DRAFT SER -- SHIPMENT OCONEE FUEL TO MCGUIRE STATION

Attached markup of Section 4 to subject SER, per your request.

4.0 RADIATION SAFETY
EFFECT OF TRANSHIPMENT ON CONSTRUCTION
FORCE AND OTHER NON-OPERATIONS STATION PERSONNEL

FIG 4-1

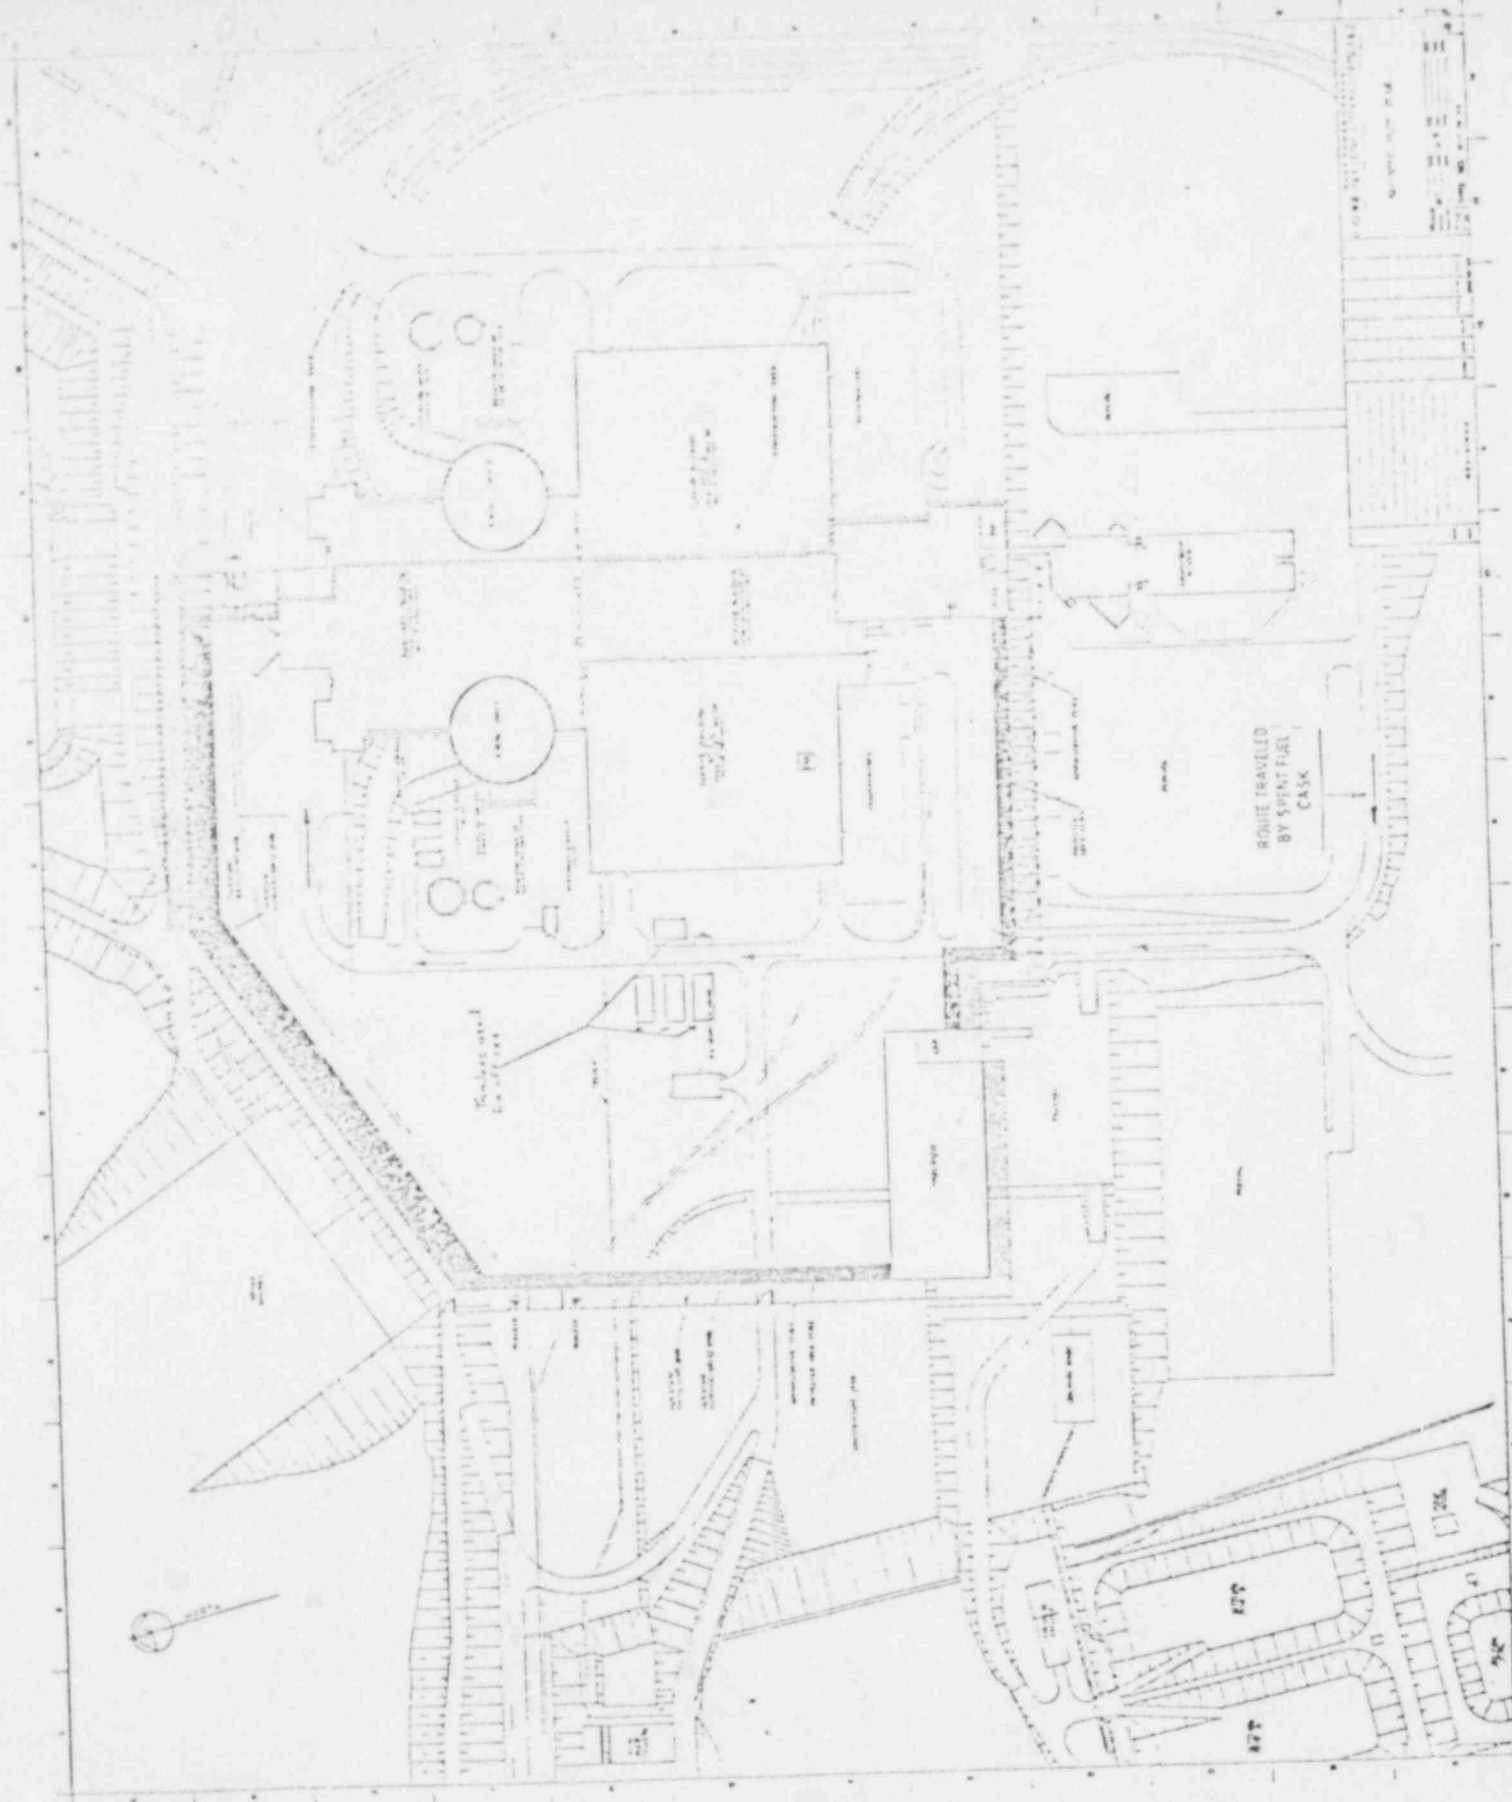
At the McGuire site, the shipment will enter the DPC road off of N.C. Route 73, travelling 0.3 miles, then pass through the split parking lot and stop at the Security Gate to gain admission to the Station protected area. The shipment would then move directly north past the warehouse, turbine building, four trailers used as temporary offices, then turning east to the north end of the auxiliary building where the spent fuel storage pool is located. See Figure 4-1.

The temporary barrier system described by DPC appears complex. It is not easy to determine from the drawings ^{how difficult} ~~if~~ it will be ~~difficult~~ to bypass. Its penetrability should be judged after it has been completed. However, even if a construction worker should bypass it for some reason, it is unlikely that he would choose to go to the spent fuel storage area in the far corner of the Auxiliary Building. That area is not on a route to anywhere.
